7 August 2020

**RE: Boco Rock Wind Farm Modification 1 (MP09_0103-Mod-1)
Amendment to the Modification – further reduction to Approved WTG locations**

Figure 1: Amended Project layout including Stage 1 and proposed Stage 2

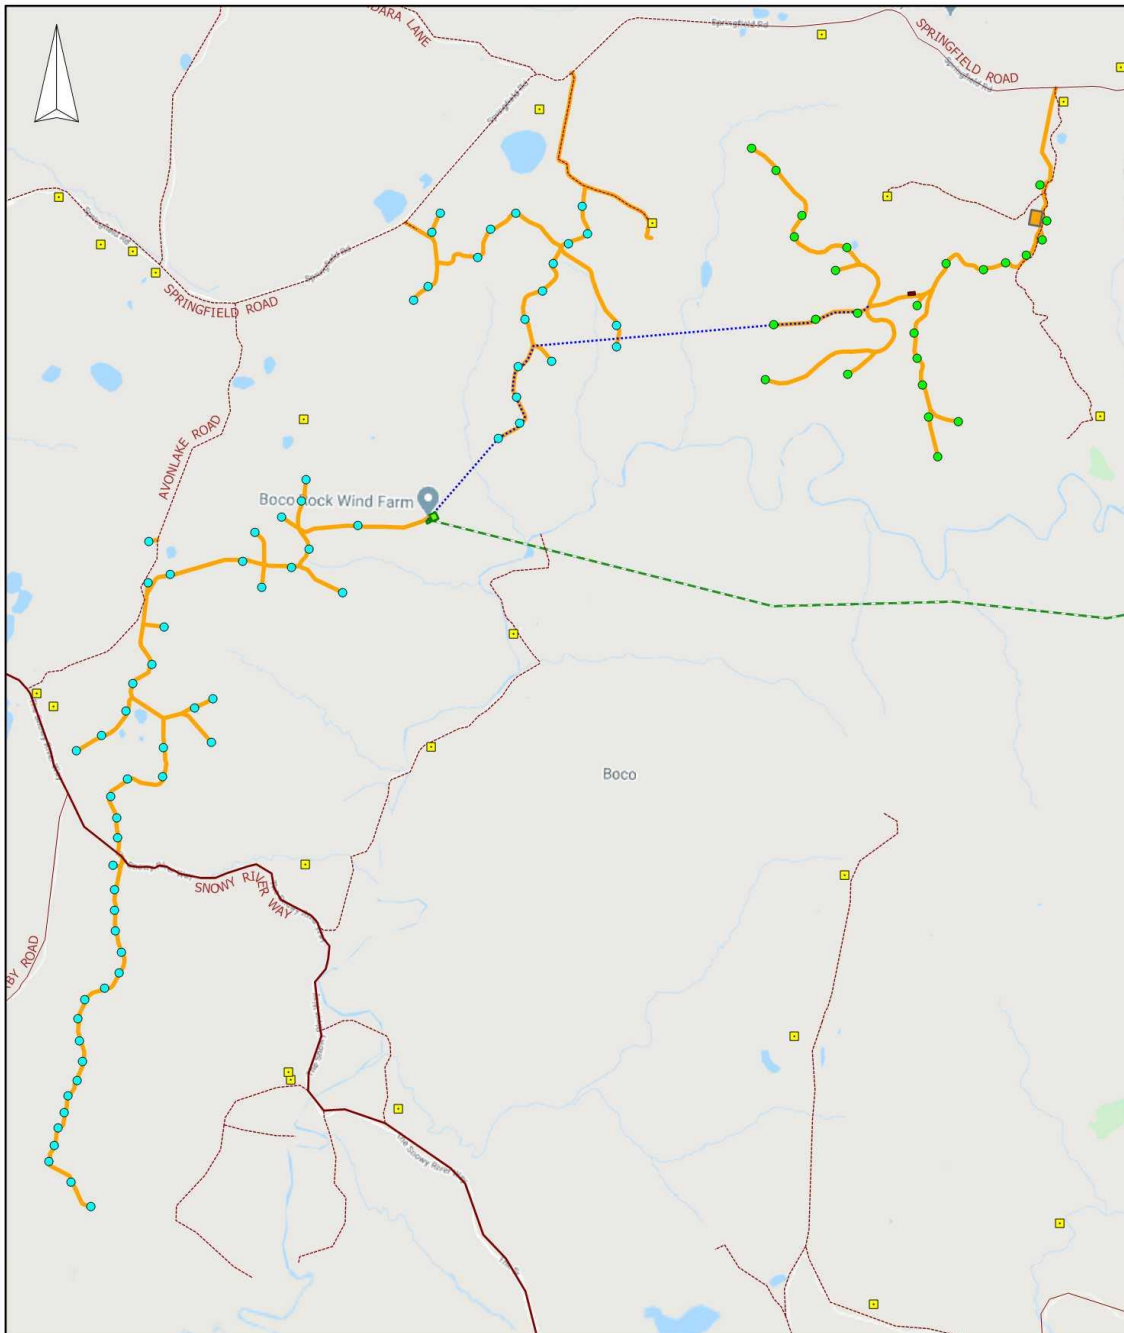
This letter seeks to amend the project to remove a further 23 approved WTG locations, (i.e. all approved WTGs from the Boco Cluster). As a result, the impacts from the 23 WTGs as well as over 25 km of access tracks and electrical cabling will be removed from Stage 2. Details of the project description as updated since the Amendment Report and an impact assessment considering the removal of the Boco Cluster are provided below.

Overall, the Modification is forfeiting 35 from 55 approved WTGs and associated infrastructure yet to be constructed within the Yandra and Boco Clusters (see and Figure 2). The Modification seeks flexibility to select up to 20 WTG locations to be constructed from the remaining 25 locations identified in Figure 1 following approval. The selected WTGs would be constructed within the micro-siting allowance of 100m from the approved WTG coordinates in Annexure A.
